Arlington High School Building Committee

Meeting Date: **Tuesday, March 2, 2021 - 6:00 pm**
Location: **Conducted via Remote Participation**

AHSBC 3/2/21 MEETING MATERIALS TABLE OF CONTENTS

A.1.3.3 Drawing 2 Phase 3 Locker Rooms

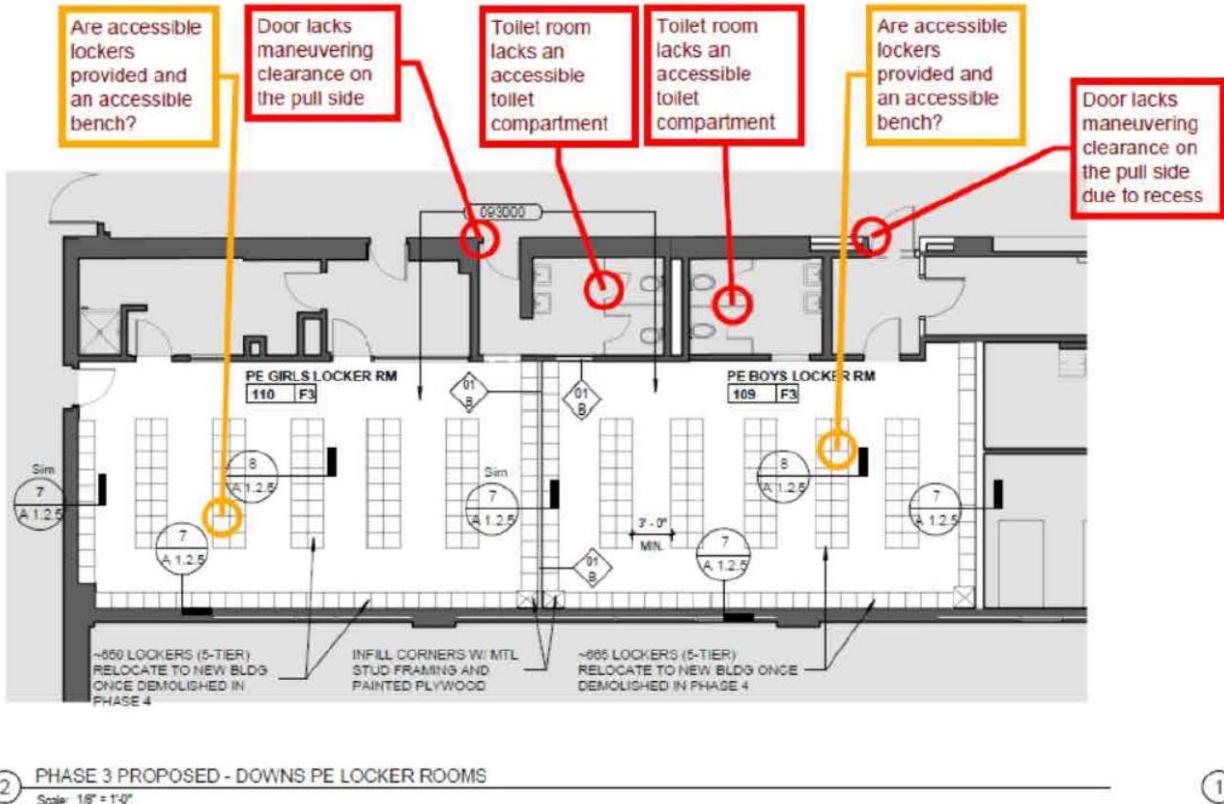
Requirement per ADA and 521 CMR: In Phase 3 locker rooms there are issues with door maneuvering clearance going into the locker rooms, lack of accessible toilet compartments and accessible benches are not depicted in the locker rooms.

This is an existing condition. Since the whole project is being constructed under one building permit but in phases, there is no proactive requirement to bring these rooms (which will be demolished) into compliance for the interim period. The newly located temporary lockers include 5% accessible lockers. As the goal for the short-term use is to maximize the quantity of lockers, this area will not include benches, but we will provide an accessible bench in each locker room.

A.1.3.3 Drawing 4 Phase 3 Locker Rooms

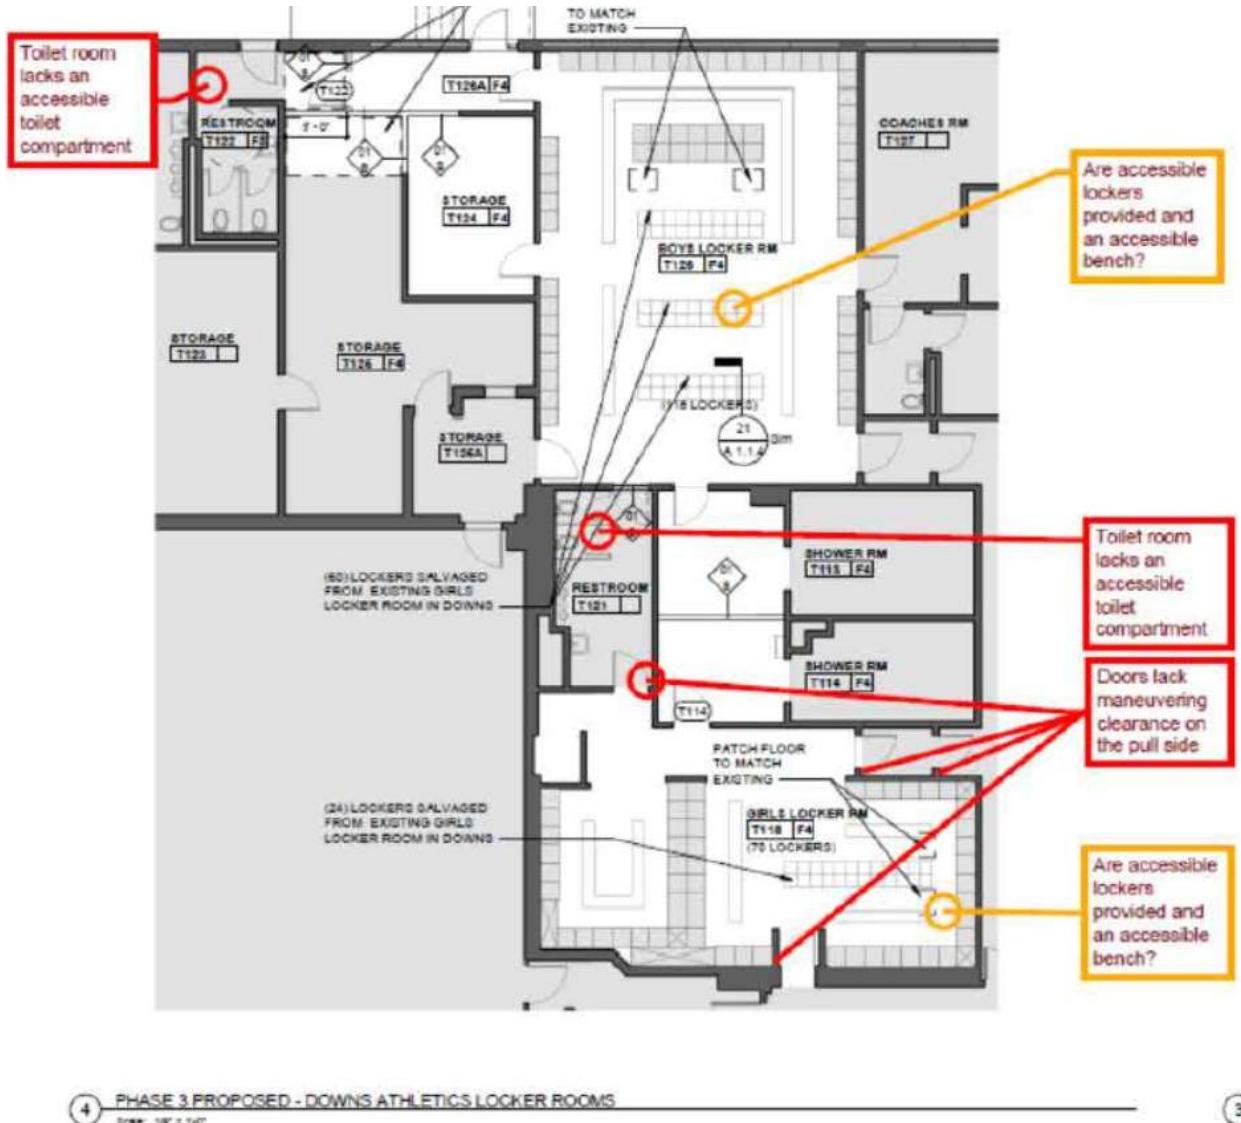
Doors to the girls' locker room and possibly to the boys' locker room lack maneuvering clearance.

It is not clear if accessible lockers and accessible benches are provided in locker rooms. 5 percent of lockers are required to be accessible and one 24" deep bench with a back that is 48" long with space alongside it for a wheelchair user to transfer is required.

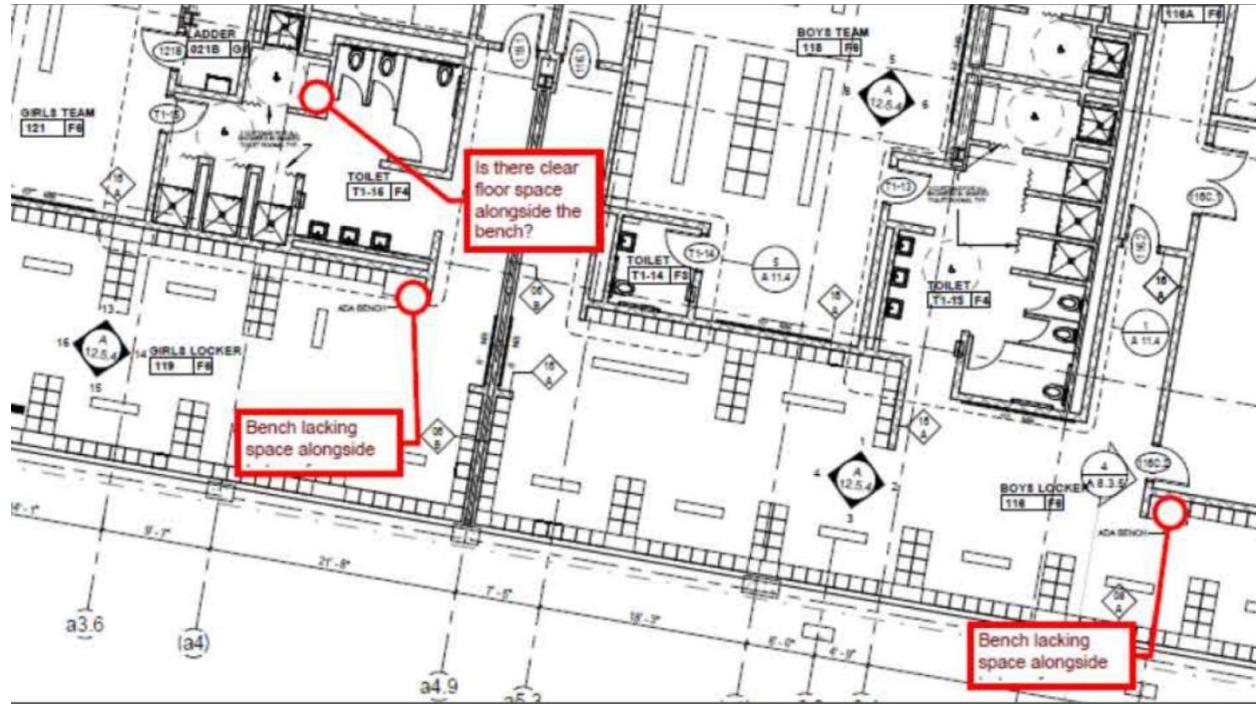
It is not clear if there is a compliant bench planned for both girls' and boys' locker rooms. The drawing below does not detail it correctly. One 24" deep bench with a back that is 48" long with space alongside it for a wheelchair user to transfer is required.

The Project Manual specifications require compliant benches at each locker room location with benches to meet accessibility requirements. Thank you for pointing out the adjacency/ transfer needs, HMFH will modify the layouts to provide the required clearances.

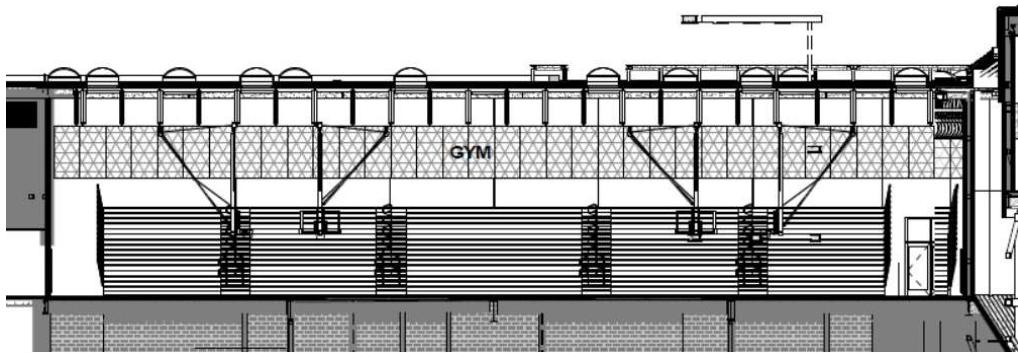
Bleachers do not appear to have integrated wheelchair spaces. Bleachers are required to have wheelchair spaces based on the seating count and comply with the 2010 ADA Standards 221.1. During the Commission on Disabilities meeting on 12.16, the architect stated that the bleachers meet these requirements, although they are not illustrated in the drawings.

This item has been responded to previously.

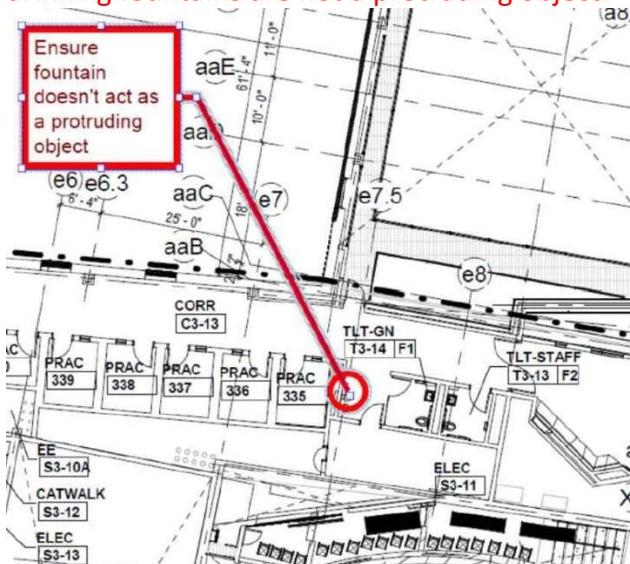
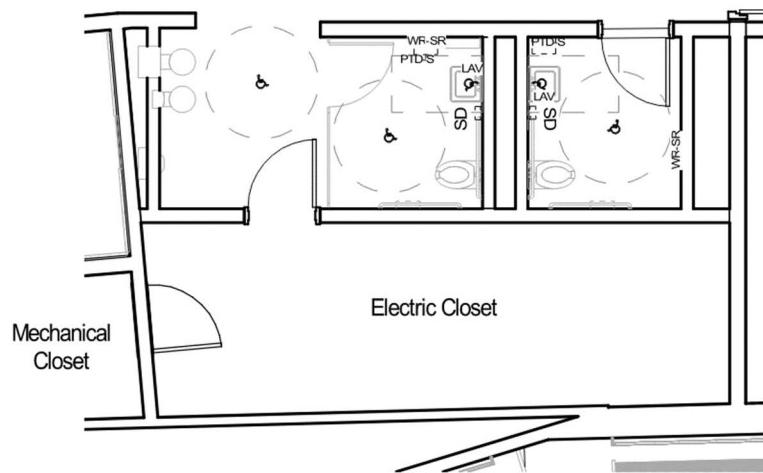
See enlarged diagram below of this area, though this is not an accessible route because the electric room is not a public space, we do have the required clearances/floor space and the drinking fountains are not a protruding object.

Enlargement of layout showing clearances provided:

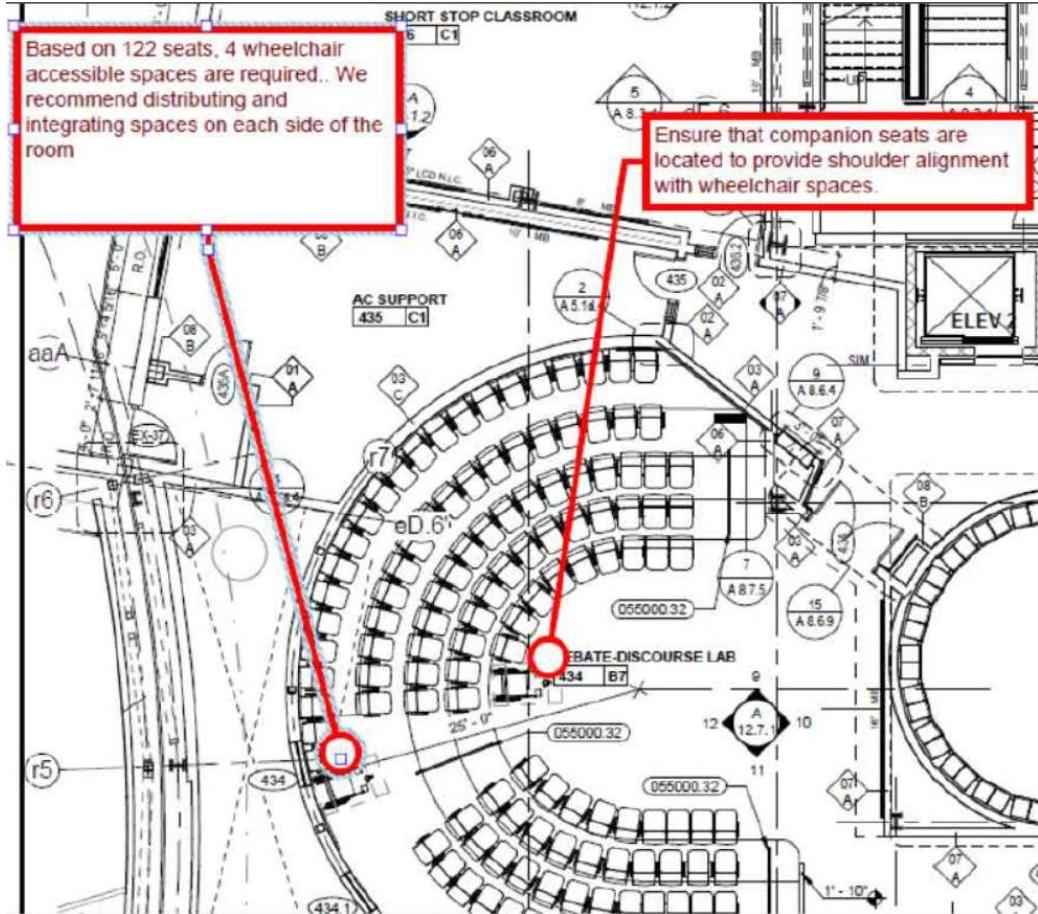
Provide 2 additional spaces for wheelchairs and ensure that wheelchair spaces and companion seats are located to provide shoulder alignment. In addition, 5 percent of aisle seats should be aisle designated seats with folding or retractable arms.

Both items were responded to previously.

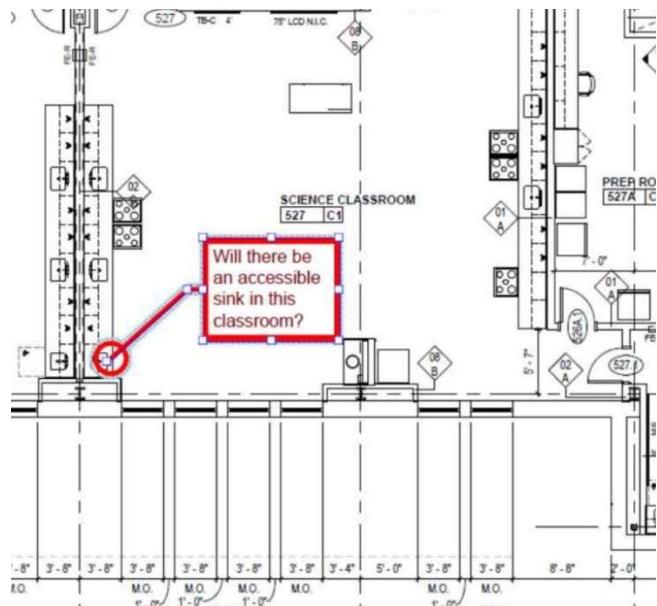
Science Classroom 527 is not labeled as having an accessible lab sink. Provide at least one accessible sink per lab.

This item has been responded to previously. There is an accessible sink in every room that has a sink, including Science room 527.

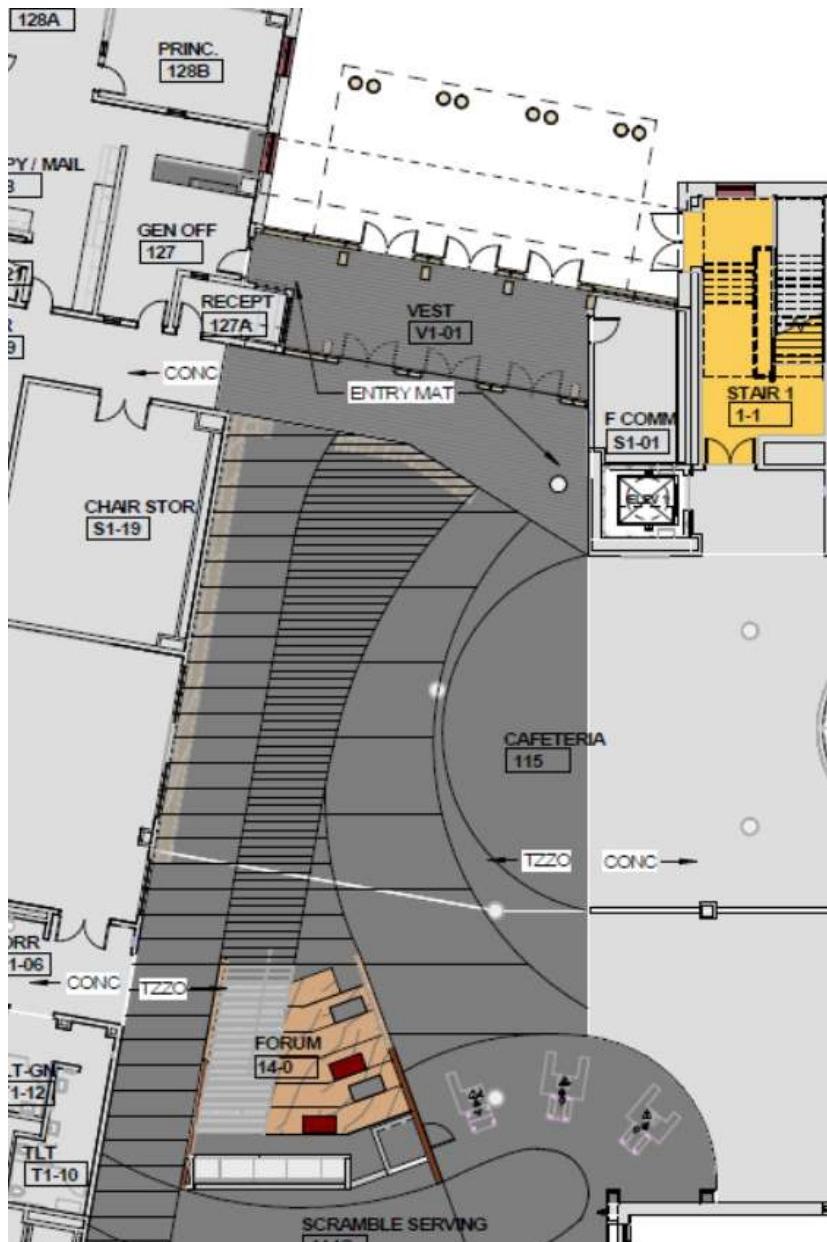
Flooring patterns by the main entrance do assist people with finding the inaccessible circulation route, however there appears to be no similar effort in directing people to the accessible circulation routes, including the elevator that is tucked around a corner at the main entrance.

The floor patterning is to be finalized and to incorporate inclusive design considerations.

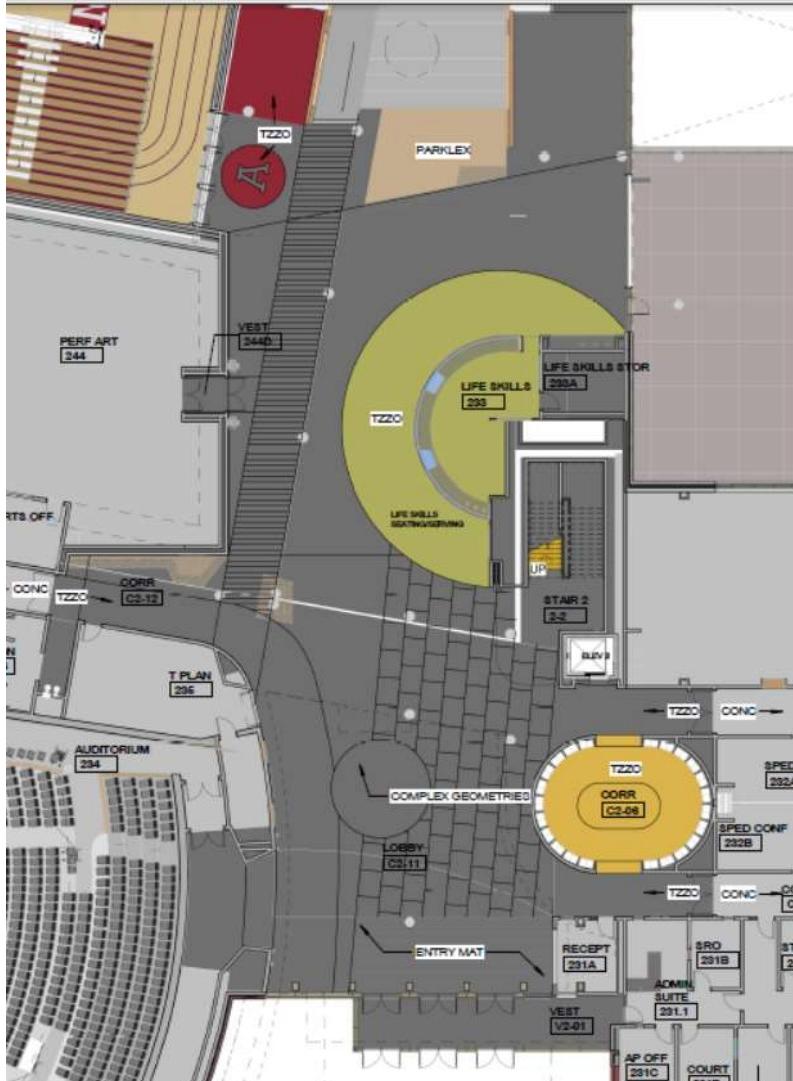
Inclusive Design: Some flooring patterns by the entrance from Mass. Ave. seem arbitrary and disorienting. IHCD recommends providing different floor surfaces (including contrasting colors and textures) to define the circulation path and enhance wayfinding.

The floor patterning is to be finalized and to incorporate inclusive design considerations.

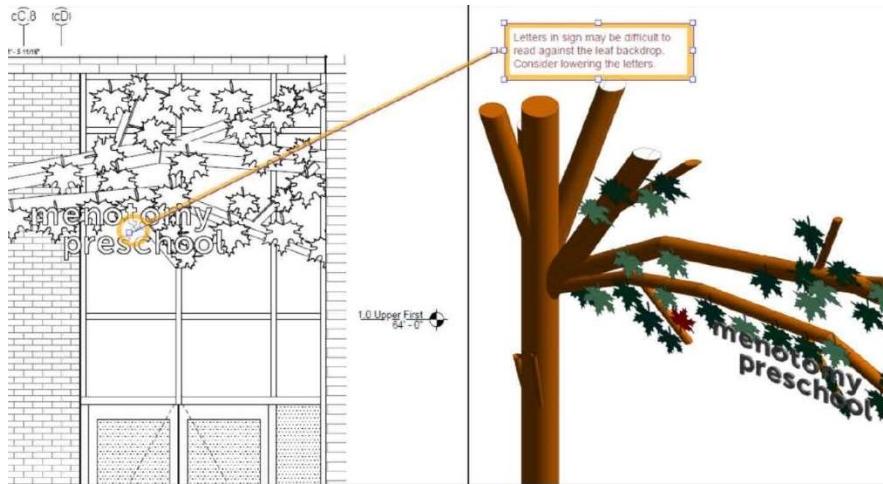
Inclusive Design: Letters may be difficult to read against the leaf backdrop. Consider lowering the letters if possible.

The contractor submittal of the letters will be reviewed/coordinated to ensure clarity.

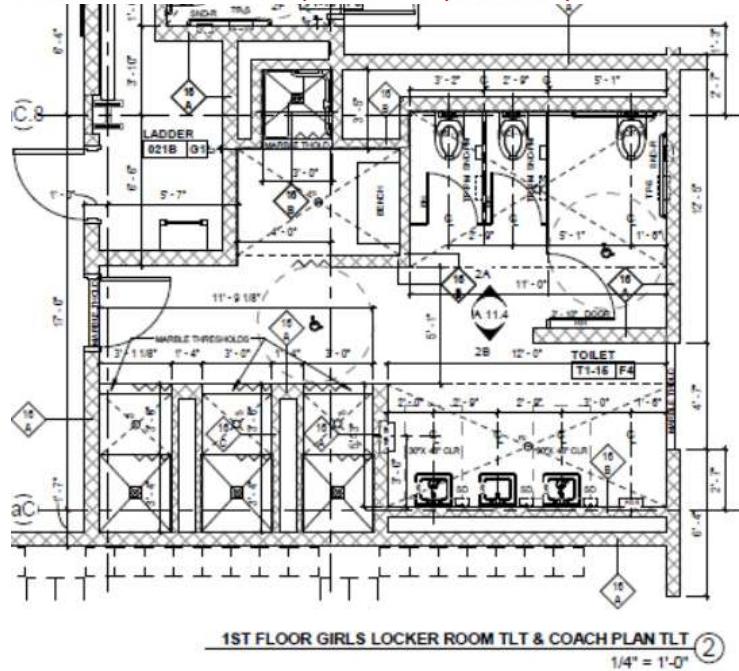
Ensure a compliant bench with room to transfer is provided and detailed in each locker room.
 This item has been responded to previously.

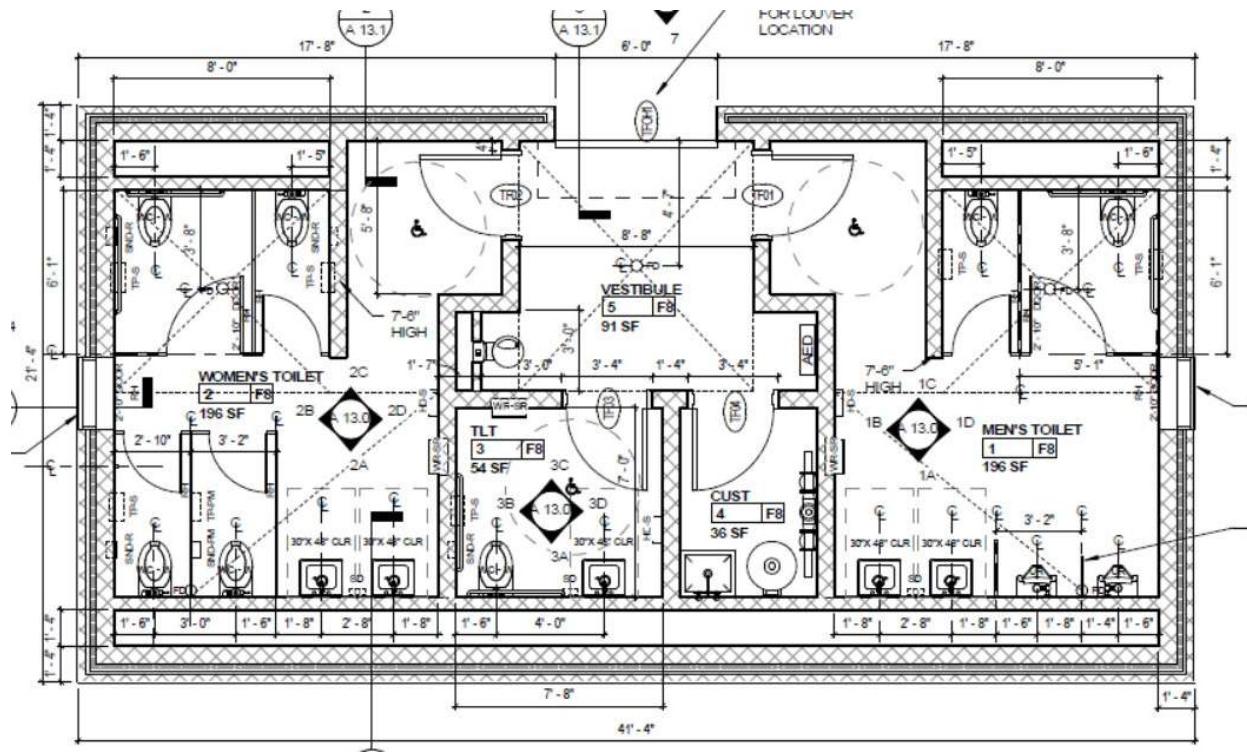
Doors of the accessible toilet compartments are swinging into the clearance required at the toilet.
